Tesla, Inc. Service Bulletin		<i>Replace Car Computer, Semi</i>	
SB-23-21-001 August 4, 2023			
Classification		Section/Group	Mobile Service
Campaign Bulletin		21 - Infotainment	Cannot Perform
Configuration			
All			
Model Year	Model	Country/Region	Build Location
2022 - 2023	Semi	North America	Giga Nevada
The model(s) and model year(s) listed are a general approximation of the affected VIN list. Refer to the VIN/Bulletin Tracker or Customer/Vehicle profile to determine applicability of this bulletin for a particular vehicle.

Figure 1

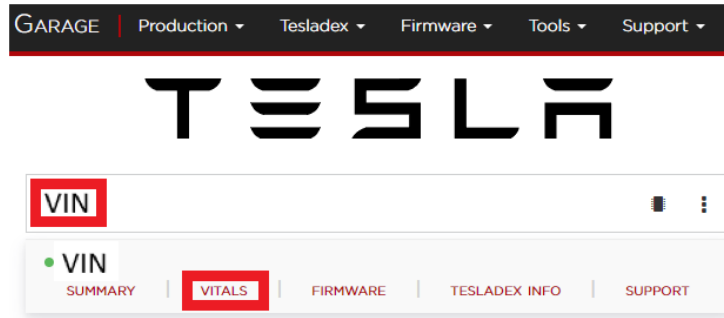
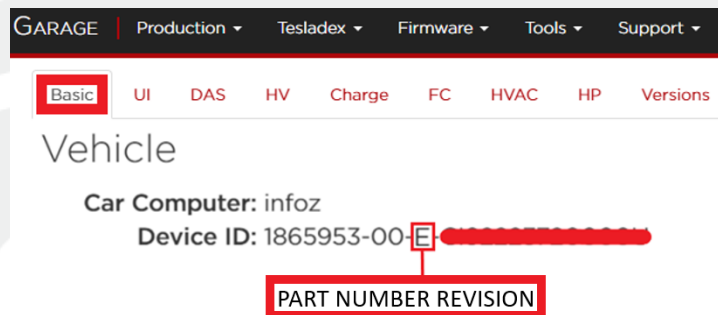
- b. Log in to [Garage](#), type the VIN into the search field, click **Vitals > Basic**, and then check the car computer part number revision in the “Device ID” field (Figures 1 and 2).

- If the car computer part number revision is 1865953-00-E or later, no repair is needed. Close out this document using correction code S012321001.
- If the car computer part number revision is 1865953-00-D or earlier, replace the car computer (refer to Service Manual procedure [2110010021](#)). Close out this document using correction code S022321001.

Figure 3

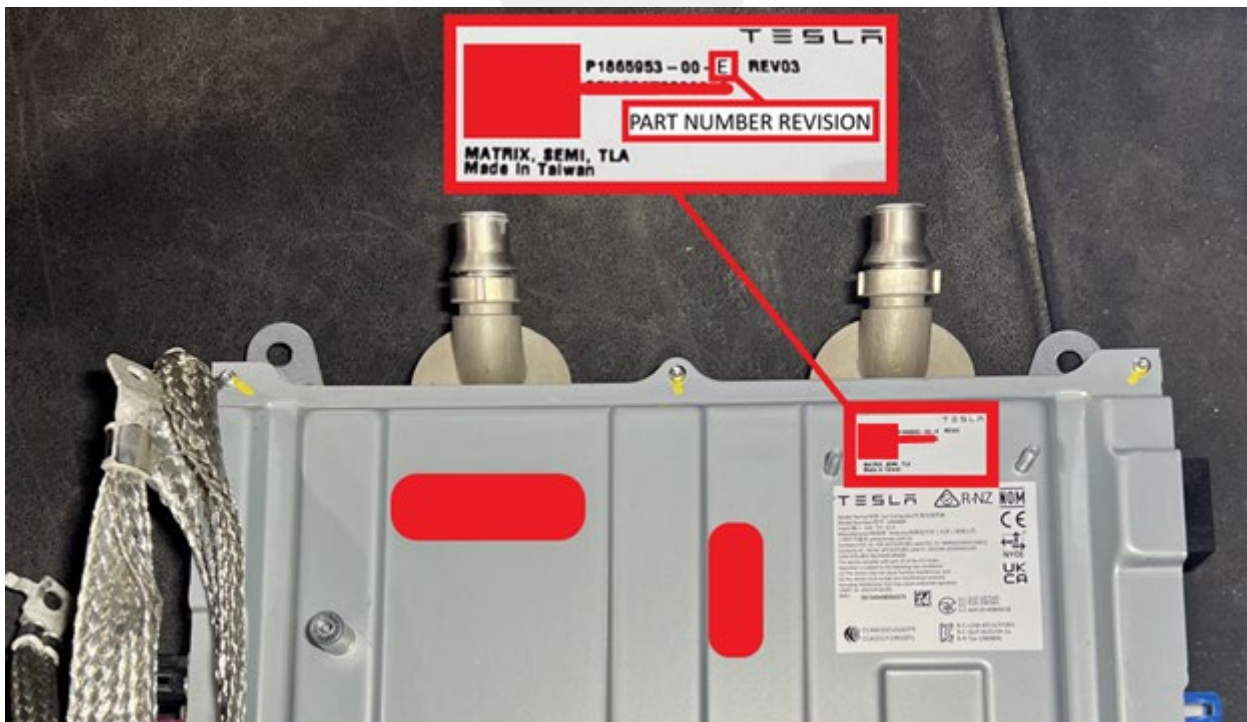
- If Garage is not available, visually inspect the car computer part number revision (Figure 3).
